# Access Compliance Report

## Public Rights-of-Way

### (Curb Ramps)

Intersection ID: 10027164	Main Street: GATEWOOD_OAKS_DR	Cross Street: N/A	Location: NE
ADA ID: 96C41E8C396D	Ramp Type: Perp	Initial Pass/Fail: Fail	Overall Compliance: No
Severity Score: 12.5			
Codes/Mitigation Info/Possible Solution		Field Measurements/Component Compliance

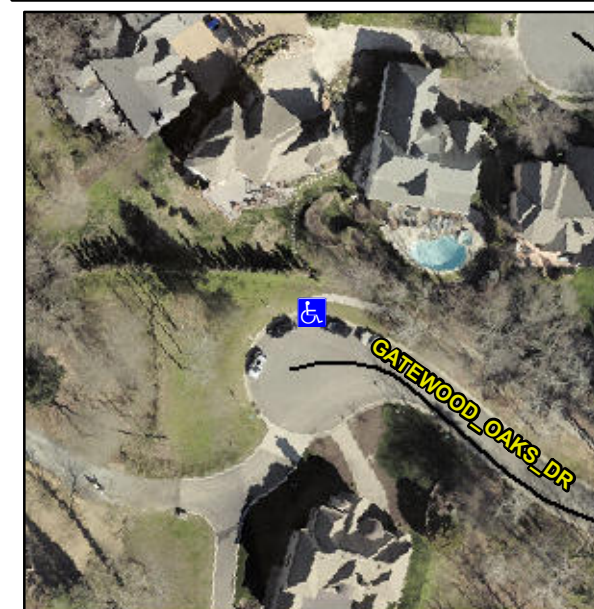
**Not Found, R304.2.2**

Compliance	Description	Data	Compliance	Description	Data
N/A	Ramp Length (in)	69.0	No	Ramp Slope (%)	9.7
Yes	Ramp Width (in)	48.0	Yes	Ramp XSlope (%)	0.9
N/A	Flare Type LT	N/A	N/A	Flare Type RT	N/A
N/A	Flare Slope LT (%)	N/A	N/A	Flare Slope RT (%)	N/A
N/A	Flare Traversable LT?	N/A	N/A	Flare Traversable RT?	N/A
N/A	Landing Length (in)	N/A	N/A	DWS Provided?	N/A
N/A	Landing Width (in)	N/A	N/A	DWS Contrast?	N/A
N/A	Landing Slope (%)	N/A	N/A	DWS Length (in)	N/A
N/A	Landing X Slope (%)	N/A	N/A	DWS Full Width?	N/A
N/A	Landing Curb? (Y/N)	N/A	N/A	DWS Offset (in)	N/A
N/A	Shared Landing?	N/A			
N/A	Gutter Ponding?	N/A	N/A	Gutter Slope (%)	N/A
N/A	Gutter Lip Ht (in)	3.0	N/A	Gutter X Slope (%)	N/A
N/A	Painted X Walk1?	No	N/A	Painted X Walk2?	N/A
	X Walk 1 Direction	To S		X Walk 2 Direction	N/A
N/A	X Walk 1 Width (in)	N/A	N/A	X Walk 2 Width (in)	N/A
	X Walk 1 Slope (%)	2.3		X Walk 2 Slope (%)	N/A
	X Walk 1 X Slope (%)	4.2		X Walk 2 X Slope (%)	N/A

**Remove & Replace Entire Ramp.**
